Product Change Notice (PCN)

PCN Number: PCN-0450031R-01

Product(s) Affected: PJ-080BH

PREVIOUS CUI DEVICES DETAIL / IMAGE	NEW CUI DEVICES DETAIL / IMAGE

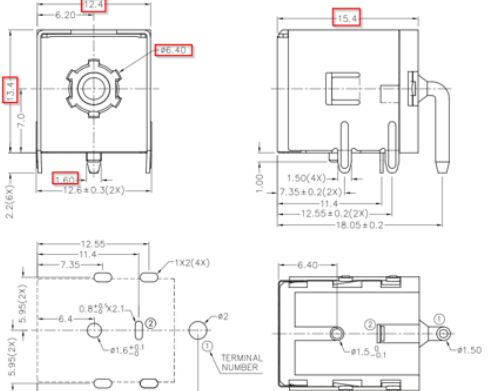
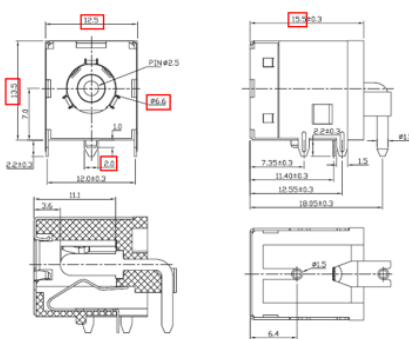
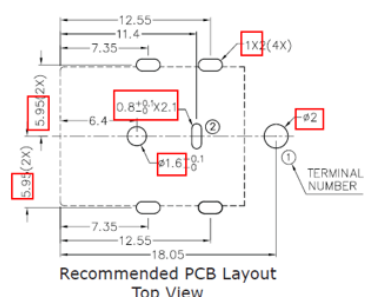
Description of Change: mechanical, material, soldering, and packaging differences as shown below:

MATERIAL	PLATING
terminal 1	brass	silver
terminal 2	copper alloy	silver
stopper	cold rolled steel	nickel
shield A	cold rolled steel	nickel
shield B	stainless steel	
plastic	PA6T or equivalent

SOLDERABILITY

parameter	conditions/description	min	typ	max	units
wave soldering	dipped in solder pot for 5 ±0.5 seconds at	255	260	265	°C
reel storage	at relative humidity <80%			40	°C
reflow soldering ³	see reflow profile	255	260	265	°C
drying conditions ⁴	parts in reel: bake at 40°C ±5°C for 72 hours parts removed from reel: bake at 40°C ±5°C for 10 hours

- Must reflow solder within 72 hours from opening vacuum packaging at a temperature <30°C & relative humidity <60%.
- When exceeding floor life by >72 hours.

DESCRIPTION	MATERIAL	PLATING/COLOR
center pin	brass	nickel
terminal 1	brass	nickel
terminal 2	bronze	nickel
shield	brass	nickel
housing	PA9T (UL94V-0)	black

SOLDERABILITY

parameter	conditions/description	min	typ	max	units
reel storage	reel opened & unused parts repacked within 2 hours: <30°C, <60% humidity reel unopened, 1 year shelf life: <30°C, <65% humidity			260	°C
reflow soldering	see reflow profile				
drying conditions	parts removed from reel over 6 hours: bake at 40°C for 6 hours

- Our Devices recommends usage of the product within 2 hours after 10th is opened. After 6 hours, Our Devices recommends drying the parts prior to use.

Reel Size: Ø300 mm
Reel QTY: 500 pcs per reel
